# Access Compliance Report

## Public Rights-of-Way

### (Curb Ramps)

Intersection ID: 30558	Main Street: GREENCREEK_DR	Cross Street: WANDERING_BROOK_DR	Location: S
ADA ID: CCF387C80AE1	Ramp Type: Perp	Initial Pass/Fail: Fail	Overall Compliance: No
Severity Score: 12.5			
Codes/Mitigation Info/Possible Solution		Field Measurements/Component Compliance

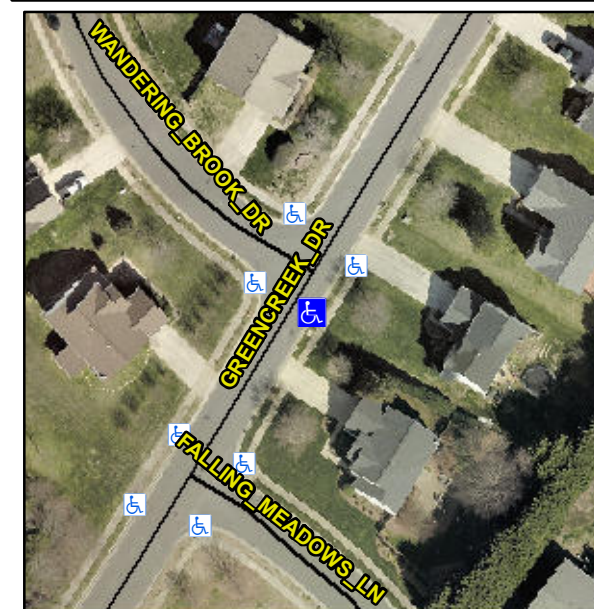
**Not Found, R304.5.3**

Compliance	Description	Data	Compliance	Description	Data
N/A	Ramp Length (in)	46.0	Yes	Ramp Slope (%)	6.5
Yes	Ramp Width (in)	48.0	No	Ramp XSlope (%)	6.4
N/A	Flare Type LT	N/A	N/A	Flare Type RT	N/A
N/A	Flare Slope LT (%)	N/A	N/A	Flare Slope RT (%)	N/A
N/A	Flare Traversable LT?	N/A	N/A	Flare Traversable RT?	N/A
N/A	Landing Length (in)	N/A	N/A	DWS Provided?	N/A
N/A	Landing Width (in)	N/A	N/A	DWS Contrast?	N/A
N/A	Landing Slope (%)	N/A	N/A	DWS Length (in)	N/A
N/A	Landing X Slope (%)	N/A	N/A	DWS Full Width?	N/A
N/A	Landing Curb? (Y/N)	N/A	N/A	DWS Offset (in)	N/A
N/A	Shared Landing?	N/A			
N/A	Gutter Ponding?	N/A	N/A	Gutter Slope (%)	N/A
N/A	Gutter Lip Ht (in)	N/A	N/A	Gutter X Slope (%)	N/A
N/A	Painted X Walk1?	No	N/A	Painted X Walk2?	N/A
	X Walk 1 Direction	To NW		X Walk 2 Direction	N/A
N/A	X Walk 1 Width (in)	N/A	N/A	X Walk 2 Width (in)	N/A
	X Walk 1 Slope (%)	1.8		X Walk 2 Slope (%)	N/A
	X Walk 1 X Slope (%)	5.2		X Walk 2 X Slope (%)	N/A

**Remove & Replace Entire Ramp.**
